MILITARY SPECIFICATION

BASE PLATE, THEODOLITE: ALUMINUM

This amendment forms a part of Military Specification MIL-B-11582C, dated 2 August 1978, and is approved for use by all Departments and Agencies of the Department of Defense.

FIGURE 1. **Base plate, theodolite.**

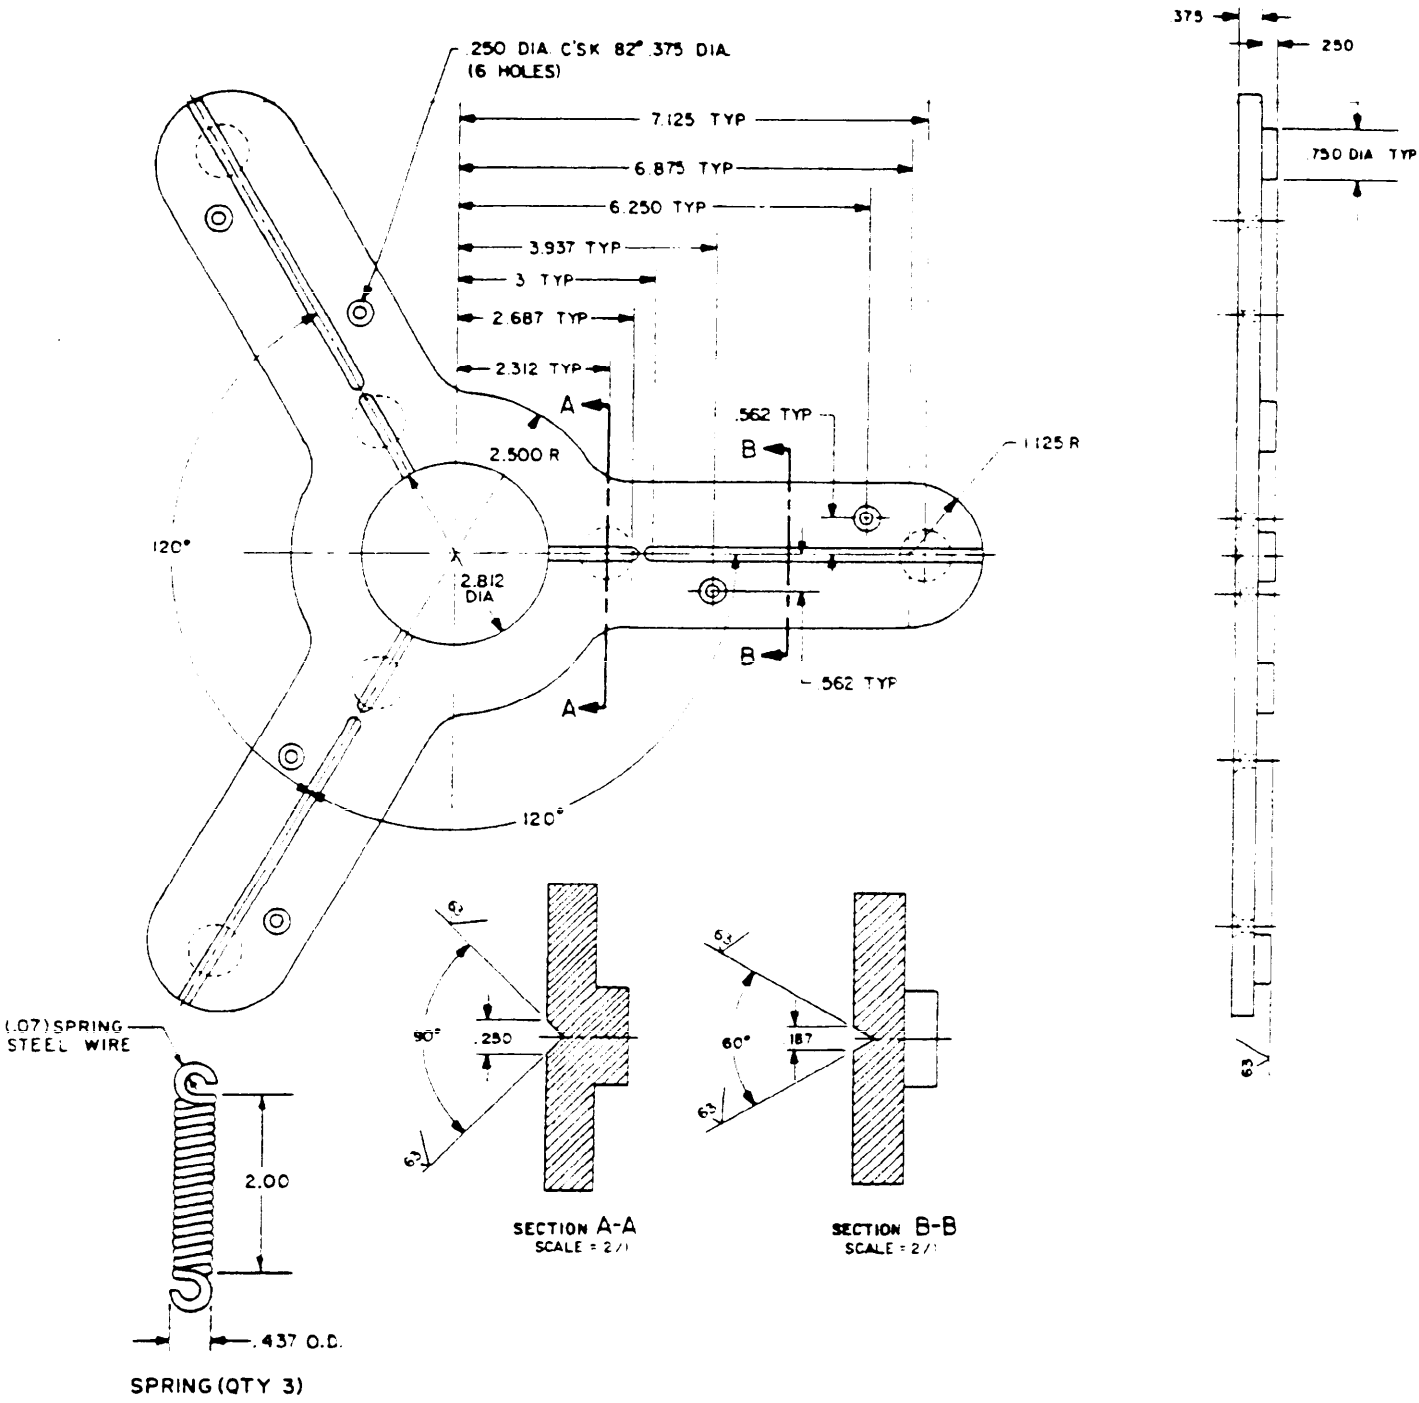
Figure 1, delete and substitute new figure 1 with steel wire springs.
